## Declaration for an Amendment to the Record of Decision

The purpose of this decision document is to present an amendment to the Record of Decision (ROD) for the Moss-American Site, which is located in Milwaukee, Wisconsin. This decision was reached in accordance with the Comprehensive Environmental Response, Compensation, and Liability Act of 1980 (CERCLA), as amended by the Superfund Amendments and Reauthorization Act of 1986 (SARA) and the National Contingency Plan (NCP).

The ROD amendment for the Moss-American site has three principal components: 1) changes in soil treatment technology, 2) potential changes in cleanup standards, and 3) changes in cover design and requirements.

**FIGURE 5  
CONTAMINATED SOIL AREAS**

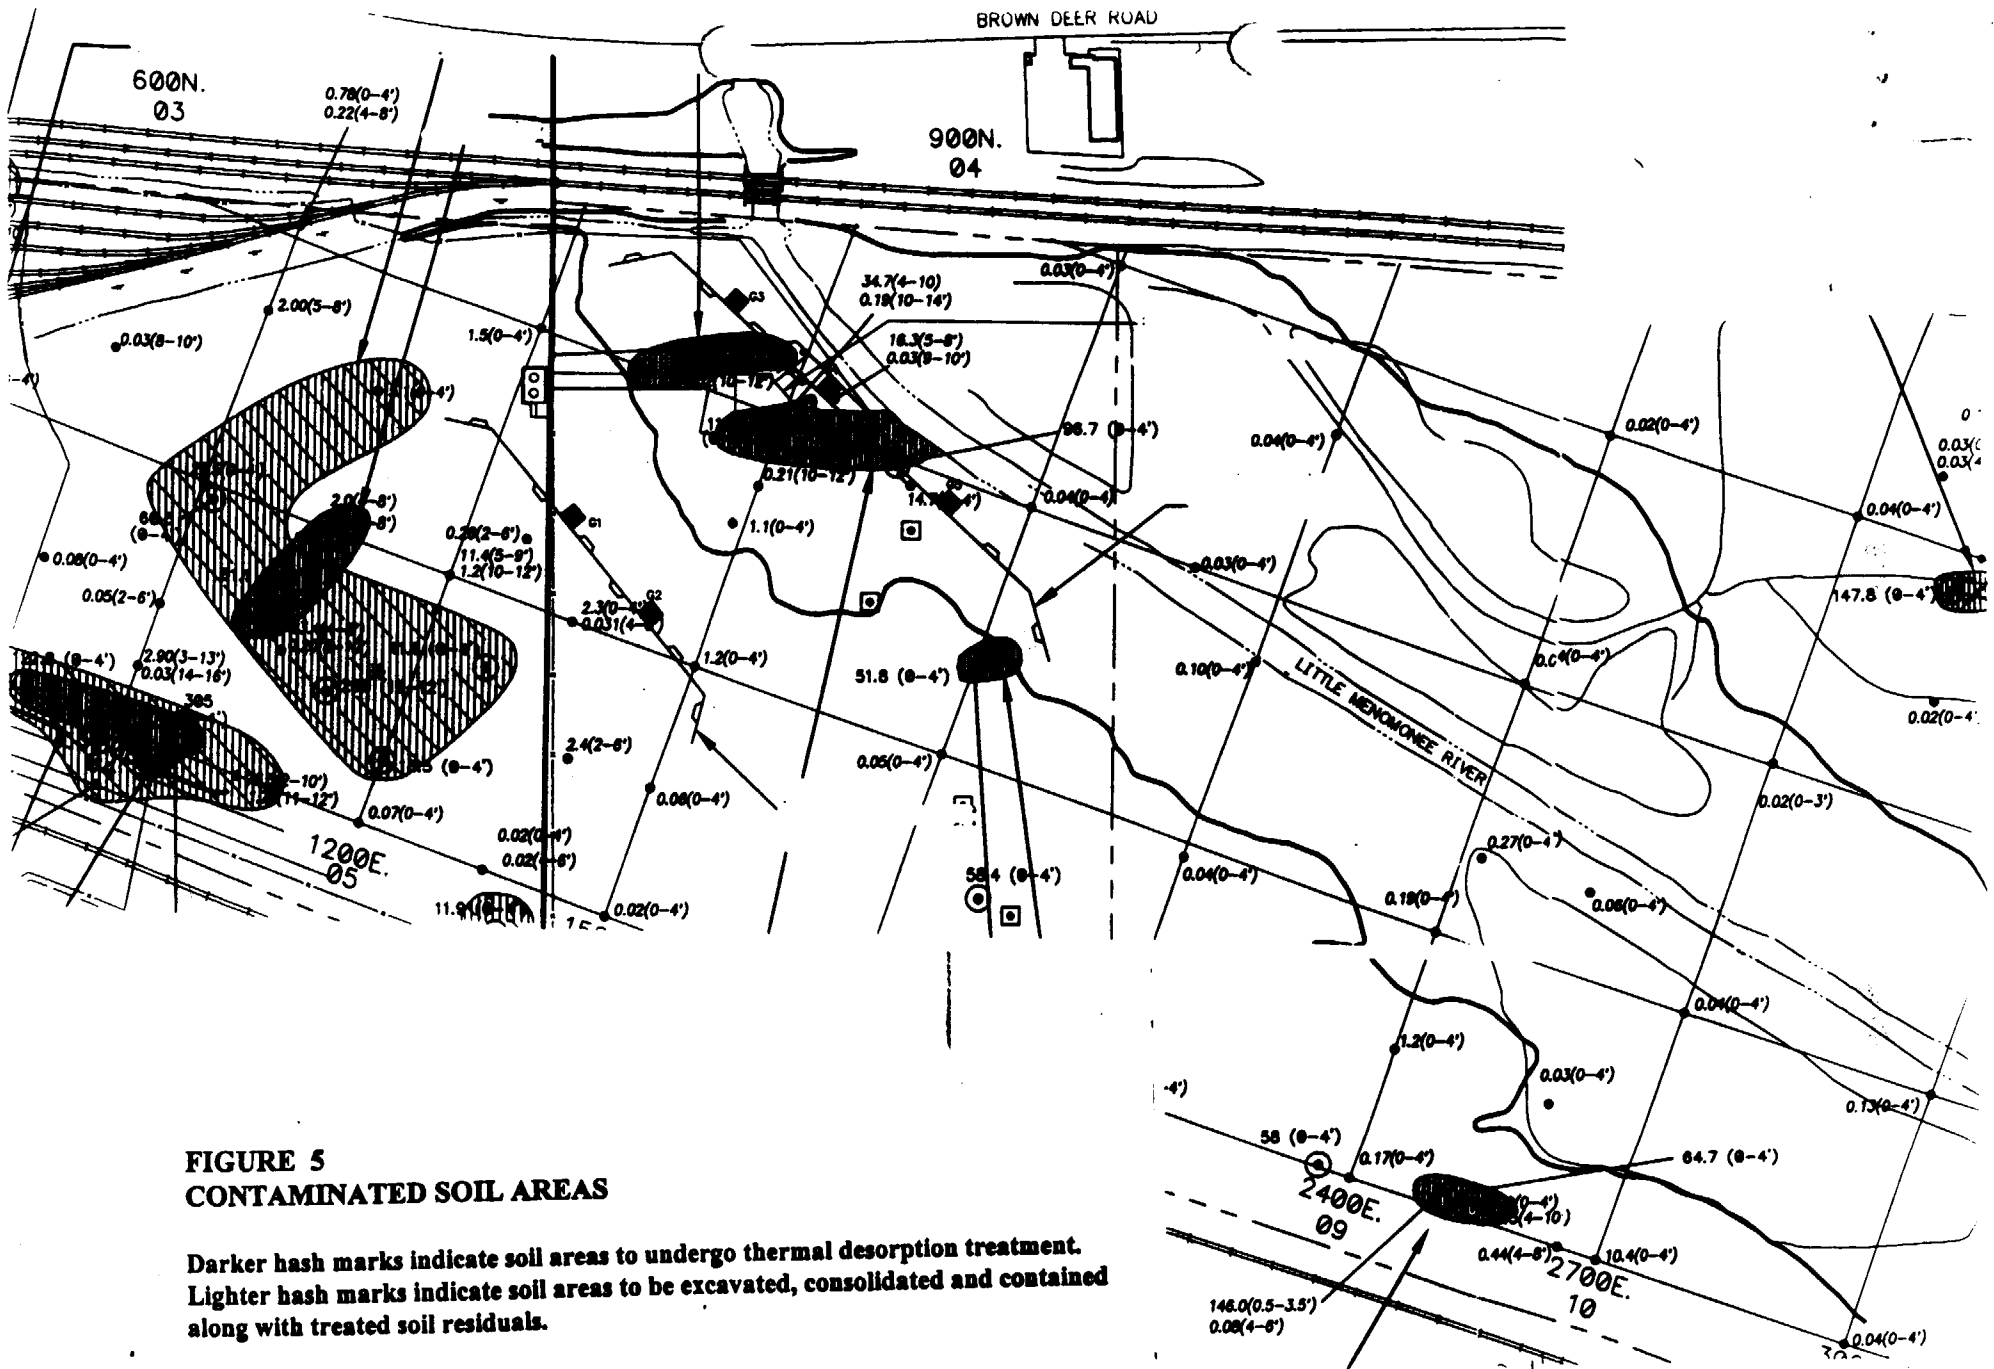
Site soil areas to undergo thermal desorption treatment would be selected for one of three reasons: 1) Direct contact "hot spots" (> 78 mg/kg CPAHs (approximately 78 parts per million (ppm)), 2) groundwater contaminant source areas having the presence of free-product creosote, and 3) soils containing contaminants exceeding Wisconsin generic residual contaminant levels (RCLs) for benzene/toluene/ethyl benzene/xylene (BTEX) and PAHs in soils which pose a source threat in attaining groundwater cleanup goals. It should be noted that these BTEX compounds occur less frequently and at levels well below CPAH compounds. However, such compounds will be considered in an effort to comply with soil cleanup standards developed since the original ROD. Residual contaminant levels (RCLs) in soils of 1.5 ppm for toluene, 2.9 ppm for ethyl benzene, 4.1 ppm for xylene, 5.5 ppb for benzene and for three PAH compounds: 0.4 ppm for naphthalene, 100 ppm for fluorene, and 48 ppm for benzo(a)pyrene are considered to pose no further threat as a source of contaminants to groundwater. Accordingly, U.S. EPA hereby adopts these RCLs for this Site. More darkly shaded areas depicted in Figure 5 indicate areas which may undergo thermal desorption treatment according to discussion in this paragraph, however, this figure may not represent the full aerial extent accurately, so further discrete soil sampling will be necessary to define these areas prior to excavation.

Darker hash marks indicate soil areas to undergo thermal desorption treatment. Lighter hash marks indicate soil areas to be excavated, consolidated and contained along with treated soil residuals.

**FIGURE 6**  
**AREAS IN EXCESS OF GROUNDWATER RCLS/PALS**

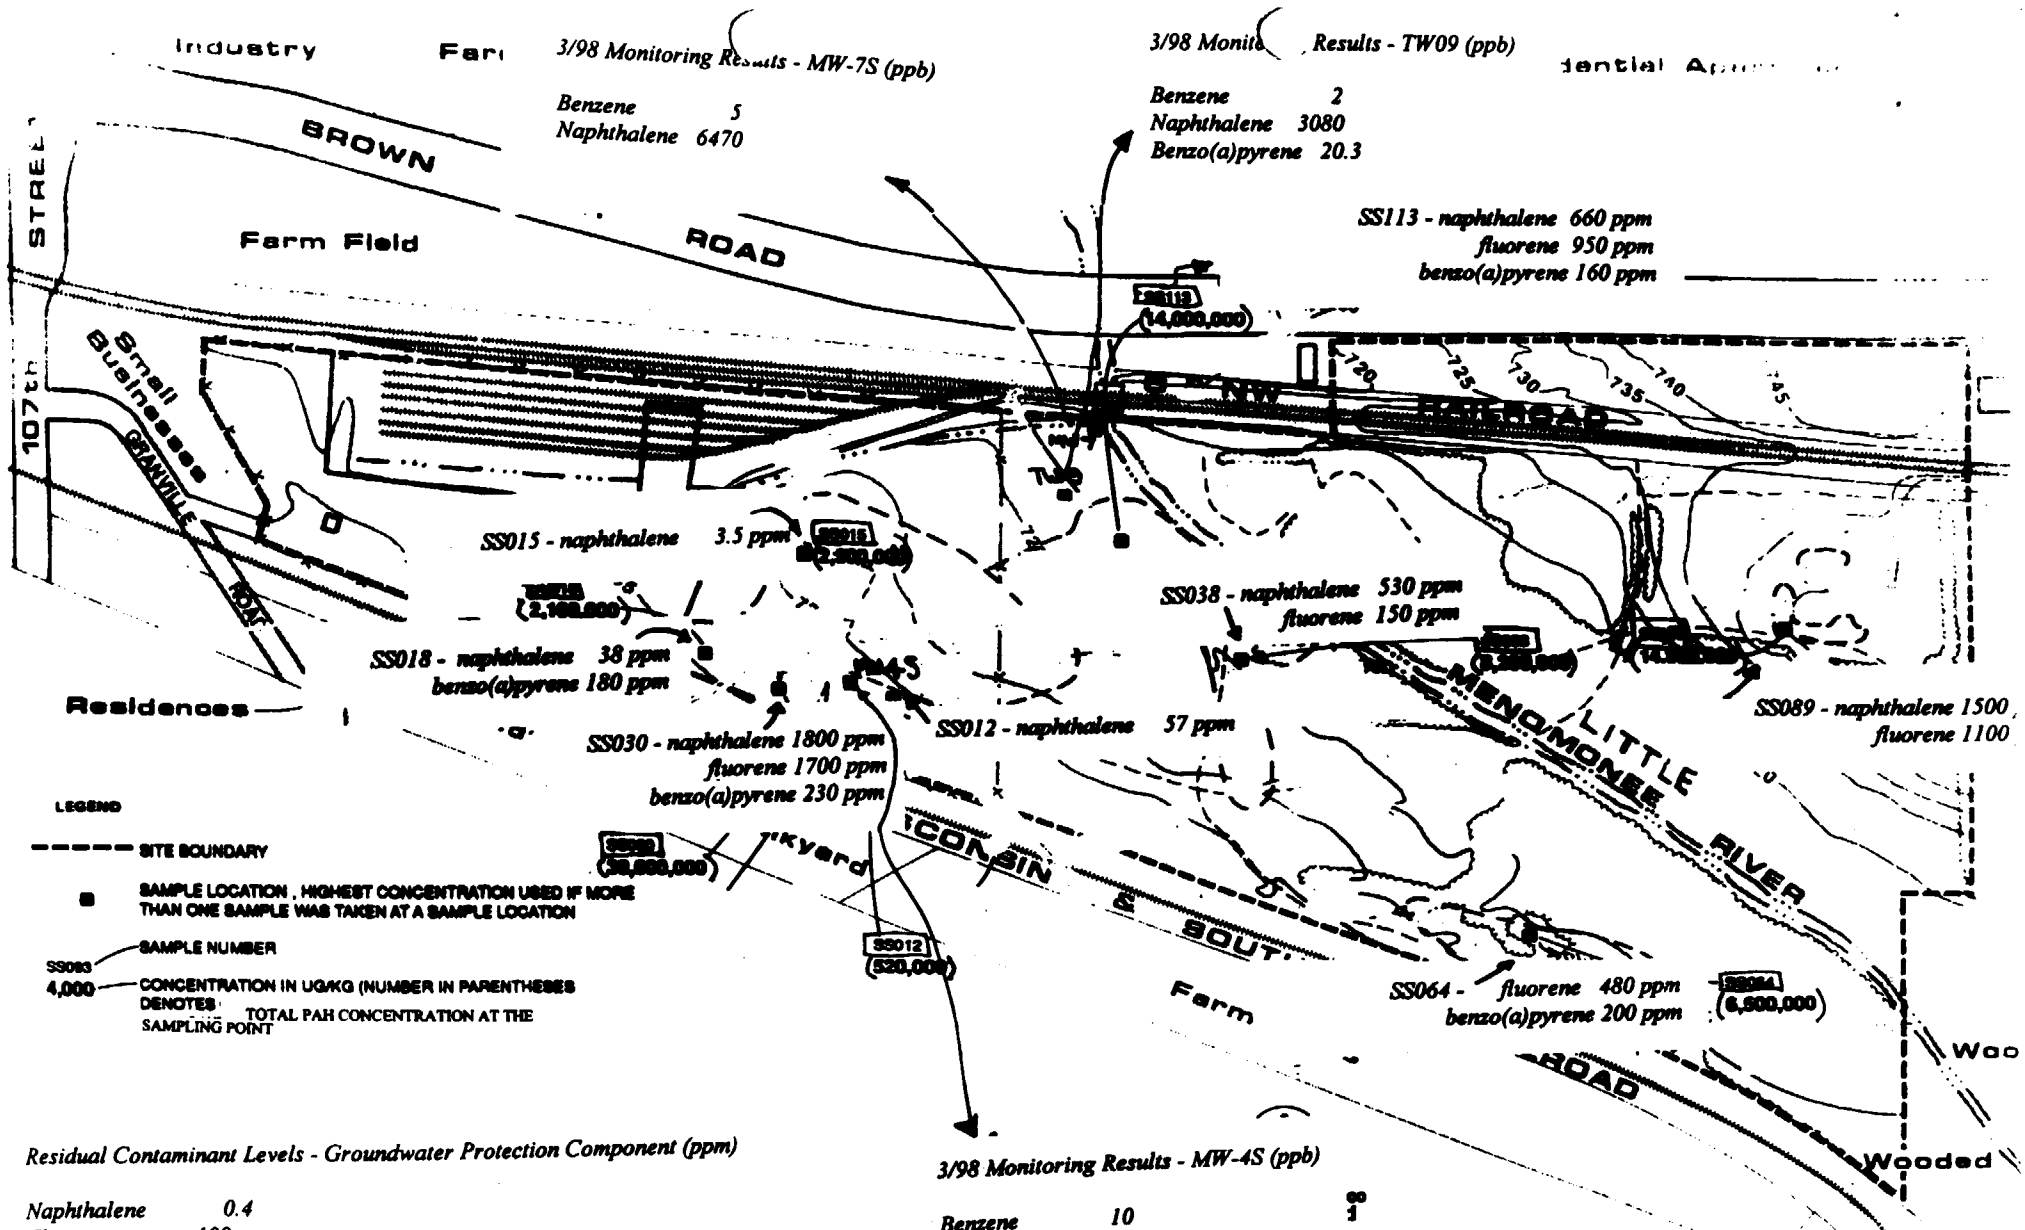
Approximate location of these points is provided in Figure 6. U.S. EPA notes that there may indeed be some overlap of areas to undergo thermal desorption between Figures 5 and 6. However, further discrete soil sampling should be conducted before treatment occurs in areas of the site that may not have been adequately characterized by past sampling efforts to determine if groundwater RCLs are currently exceeded and after treatment in the excavated areas to ensure that unacceptable threats to groundwater have been successfully addressed through attainment of the groundwater RCL.

**FIGURE 7  
FLOODPLAIN PORTION  
COUNTY PROPERTY ON  
FORMER CREOSOTE SITE**

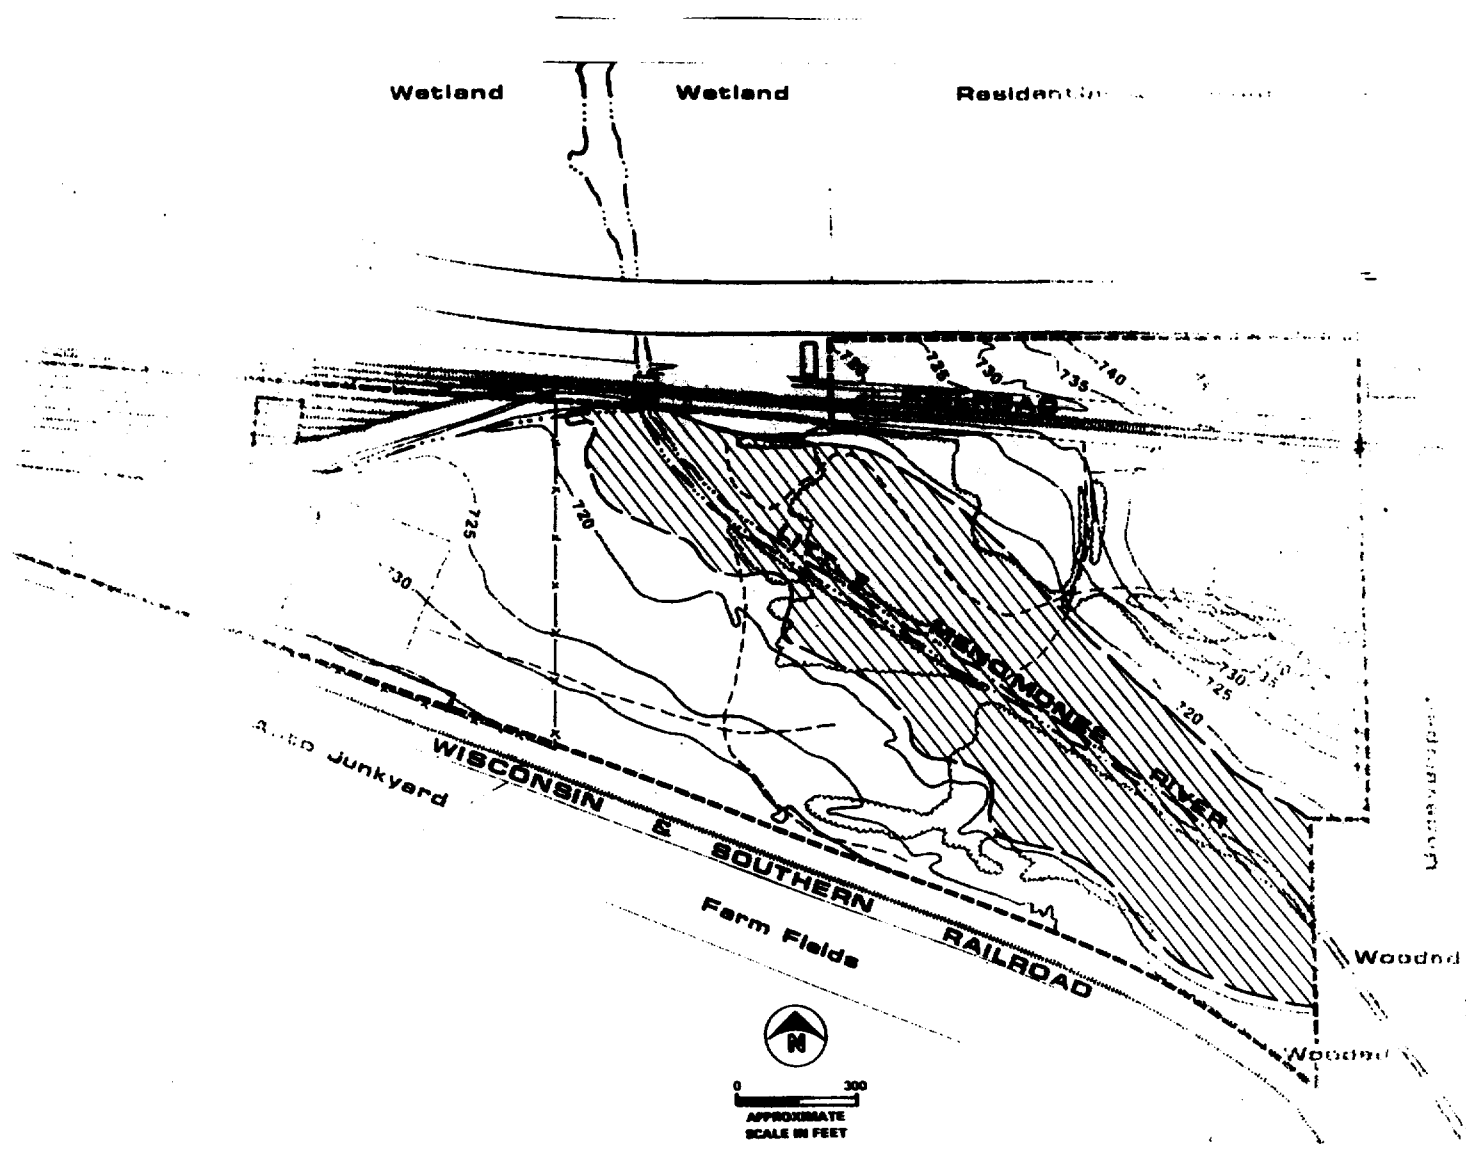
As noted above, a Park and Open Space plan adopted by the County in 1991 which calls for enhanced recreational opportunity in river corridor settings such as the Little Menomonee. For Milwaukee County property which is located in the floodplain of the Little Menomonee River and is a part of the former creosote plant, U.S. EPA believes that a recreational exposure scenario may be applied. This is consistent with the system of parklands and trails maintained by Milwaukee County downstream of the former wood preserving facility. Industrial development is not likely within the floodplain. Applying the procedures in NR 720 to determine a site-specific RCL, a cleanup level of approximately 49 ppm CPAH provides sufficient direct contact protection for the recreational user. However, U.S. EPA will not adopt 49 ppm CPAH as the cleanup value for County-owned floodplain land on the former creosote plant. Chapter NR 720 series requires the soil to surface water pathway be addressed. After considering needed erosion control measures and sediment remediation values, U.S. EPA adopts a figure of 15 ppm CPAH to be the surface water RCL for the entire former creosote plant and the recreational cleanup value for the County owned portion of the site in the floodplain.

Soils in the floodplain under B. that remain in place and exceed the direct contact RCL for recreational usage shall be covered with 2 feet of clean soil and 6 inches of vegetated topsoil, provided appropriate deed restrictions and maintenance agreements are obtained within 180 days after the effective date of this amendment, and provided that the necessary floodplain easements are obtained for filling in the floodplain. If the floodplain easements cannot be obtained, these soils shall be removed so that the remaining soils may not exceed the NR 720 residential direct contact RCL values for all the contaminants of concern. This timeframe may be extended upon the approval of U.S. EPA in consultation with the WDNR.

FIGURE 8

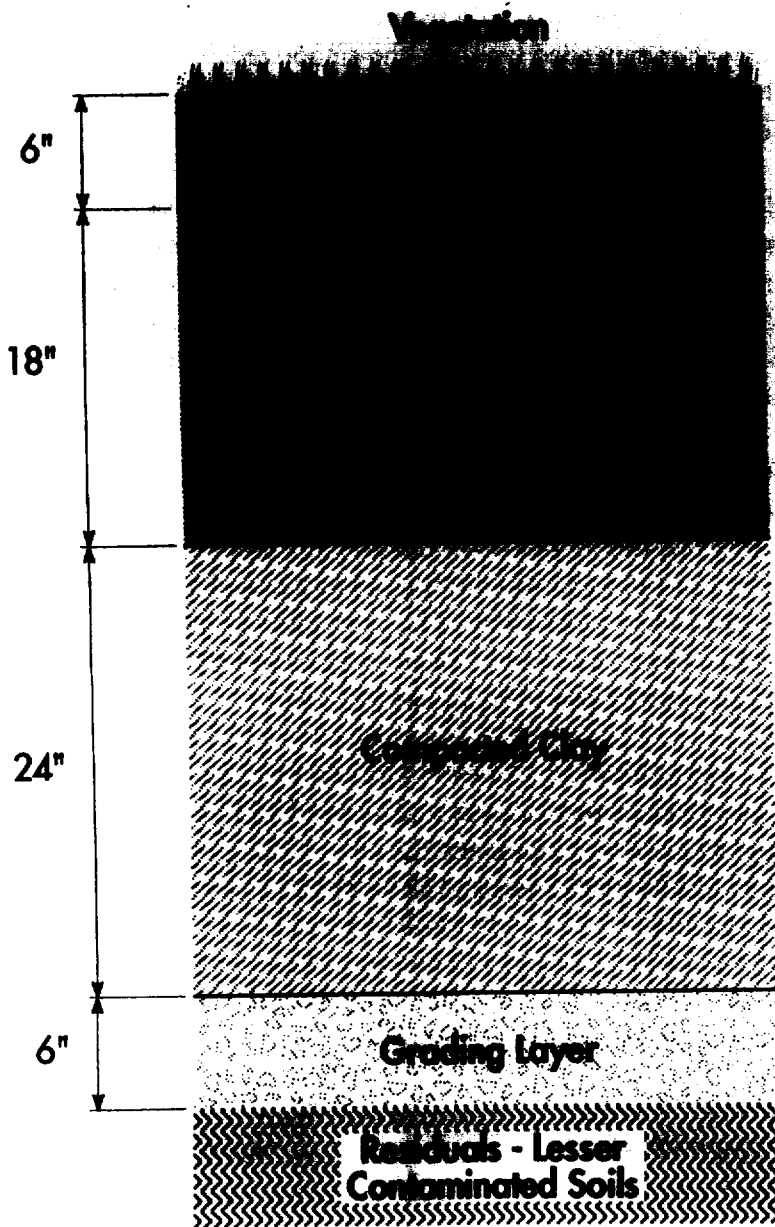
The design of the s. NR 504.07 cover system includes a clay cap (approximately 24 inches thick) topped with a suitable frost-protection soil layer (approximately 18 inches thick) A cross-section of such cover is depicted in Figure 8.
